Executive Director's Recommendation

Commission Meeting: January 7, 2016

PROJECT National Capital Region Campus Renovation Project and Park Police District 1 Substation --East Potomac Park 1100 Ohio Drive, SW, Washington, DC	NCPC FILE NUMBER 7703
SUBMITTED BY United States Department of the Interior National Park Service	NCPC MAP FILE NUMBER 1.52(38.00)44206
REVIEW AUTHORITY Approval per 40 U.S.C. § 8722(b)(1) and (d)	APPLICANT'S REQUEST Final approval of site and building plans
	PROPOSED ACTION Approve as requested
	ACTION ITEM TYPE Consent Calendar

**National Capital Region Campus Renovation Project
and Park Police District 1 Substation**

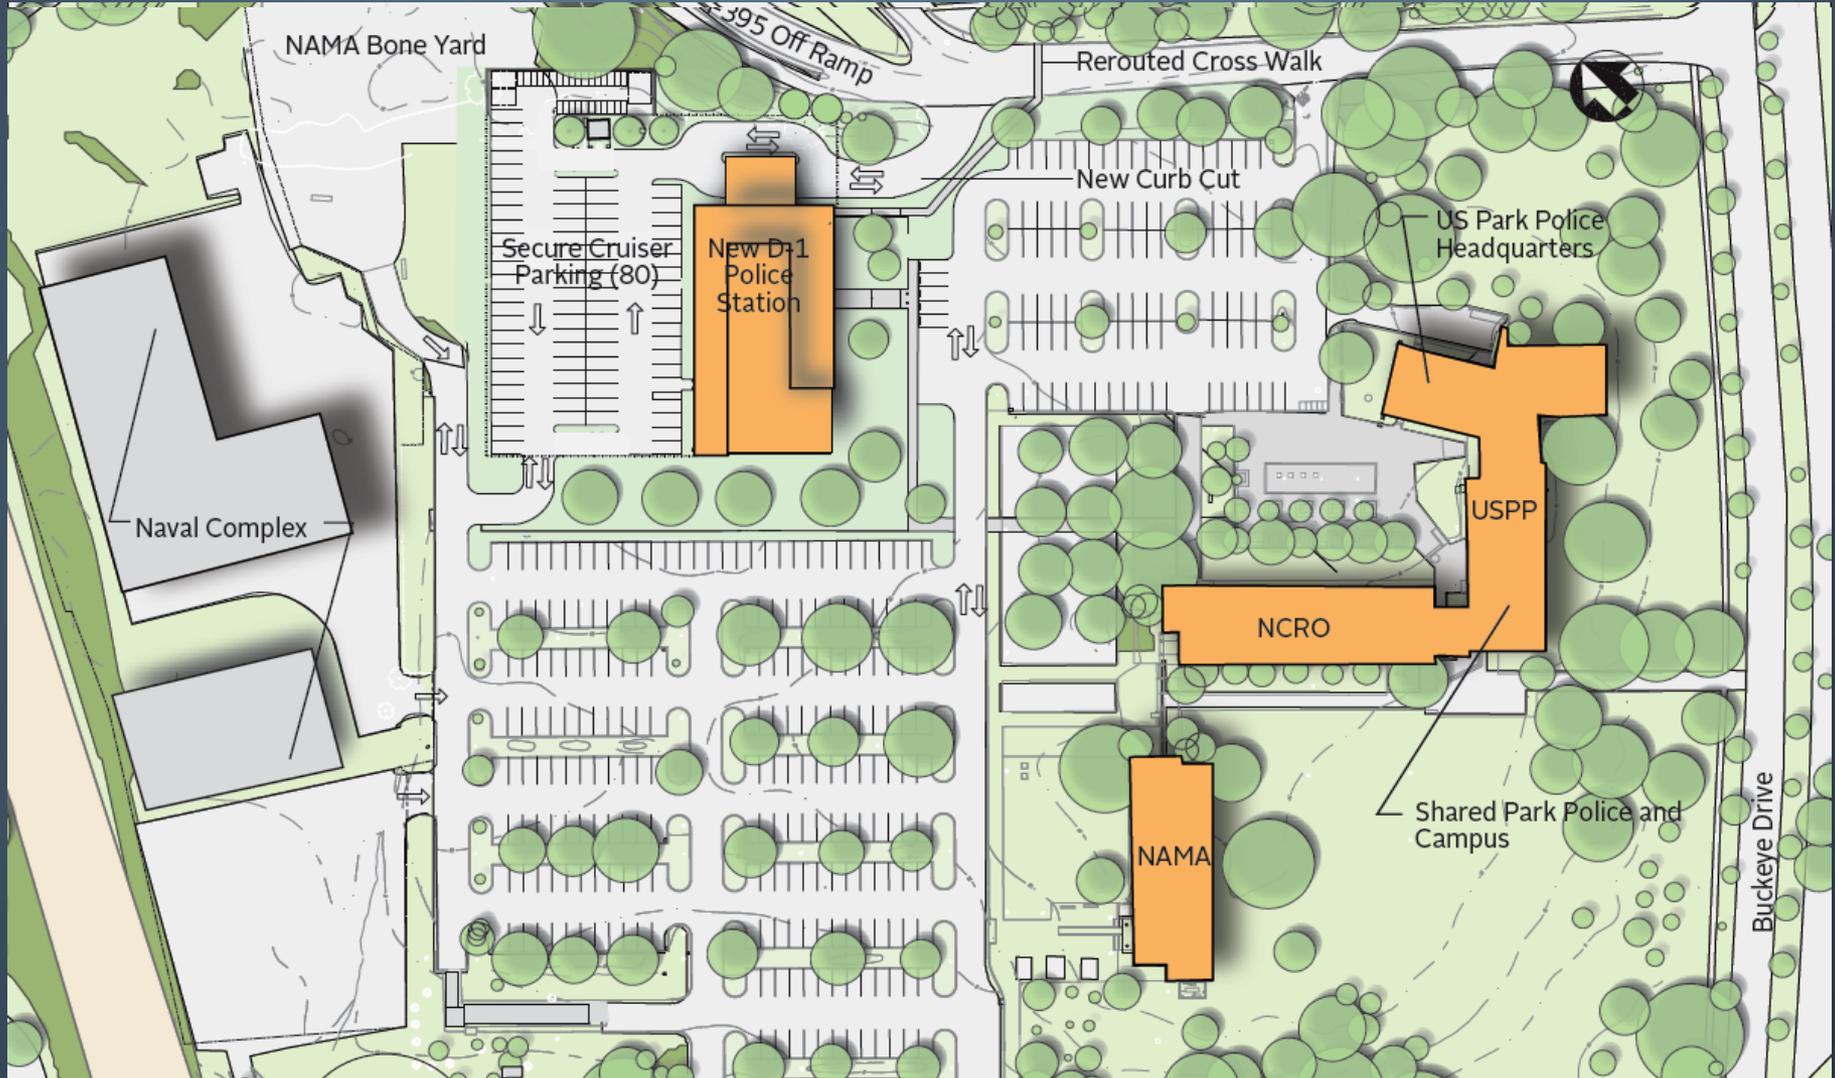
NPCP STAFF NOTE: This map shows the 500 year floodplain in orange which includes land at elevations between 11.3 feet and 14.9 feet. The D1 Police Station facility is designed to an elevation of 14.3 feet, which meets one of the standards defined in Executive Order 13690.
